Interactive comment on “Simulation of rock salt dissolution and its impact on land subsidence” by A. Zidane et al.

A. Zidane et al.

Authors comments to referee #1

Fig. 12: Flow directions within the 2D cross-section

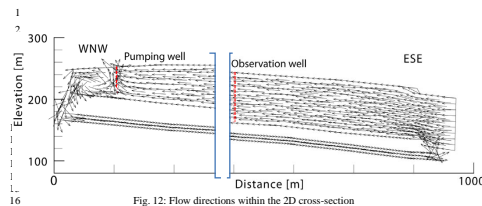
Section 4. The two §P74L6 to P74L21 belong into the Conclusions section. Will be added in the revised version. Fig. 12 should be presented much earlier to set the stage for your investigations. Will be added in the revised version.
